UNITED STATES PATENT AND TRADEMARK OFFICE

| 10/727,096 | 12/02/2003 | David K. Swanson | 03-0242 (US01) | 6001 |

Office Action Summary

Claim Rejections - 35 USC § 103

Figure A

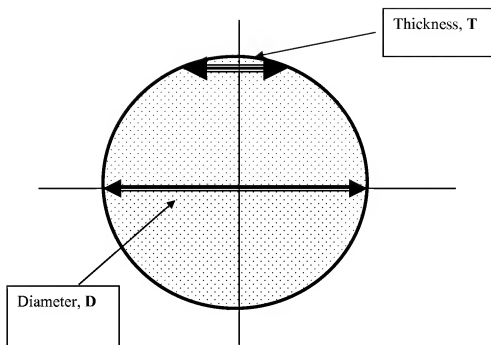
Regarding claims 31-33 and 37-39, Samson in view of Geeham in further view of Lundback disclose the claimed invention except for the stimulation element defining a perimeter of about 1.5 mm to 3 mm, a thickness of about 0.01 mm and a diameter of about 0.5 mm to 1.0 mm. The examiner takes official notice of the perimeter as it is trivial to provide the electrically conductive members, i.e. the electrodes of Geeham with perimeter of about 1.5 mm to 3 mm corresponding to the cross-sectional area of wires (W, see col. 3:65 – col. 4:18 and figure 4) and a thickness of about 0.01 mm in order to electrode with its fully functioning capabilities. It should be further noted that a circular perimeter of 1.5 mm to 3 mm yields a diameter of about 0.5 mm to 1 mm. As Applicant has traversed the official notice rejection, the examiner now provides a prior art reference which has been cited only to support the previous official notice rejection (see MPEP 2144.03(a-d), particularly 2144.03(d)). Specifically it is the cross-section of the electrode that is relevant for this rejection. Ostroff et al. disclose an electrical tissue stimulating device and provide an electrode having a circular cross-section with diameter of 1-5 mm,

see col. 5:351-67 and figure 1. Since the perimeter, **P**, of the electrode cross-section is given by

$$P = 2 * \pi * r = \pi * D,$$

where **D** is the diameter and **r** is the radius. Therefore, in order for the perimeter, **P**, to be about 1.5 mm to 3 mm, the diameter, **D**, must be about 0.47mm to 0.95mm. Since 1mm is about 0.95mm (a difference of less than 5.3%), the perimeter and diameter recitations have been met. Regarding the thickness of about 0.01mm, it can easily be seen from the **figure A** below, given a circular cross-section, a thickness can be defined which the circular cross-section inherently has and that is about 0.01mm. Figure A depicts the electrode's circular cross-section having a diameter, **D** and thickness, **T**. It should be noted that thickness of 0.01mm is located almost at the top of the cross-section and for further illustration it should be noted the distance from the center of the circular cross-section to where the thickness is 0.01mm is equal to the square root of $(0.5\text{mm})^2$ minus $(0.005\text{mm})^2$.

Finally, Applicant may argue Gecham doesn't disclose a circular cross-section. The examiner counters with the fact that a portion of the cross-section is circular (the upper portion) and it is that portion that defines (in view of the official notice and Ostroff et al. (7,149,575)) the recited dimensions.
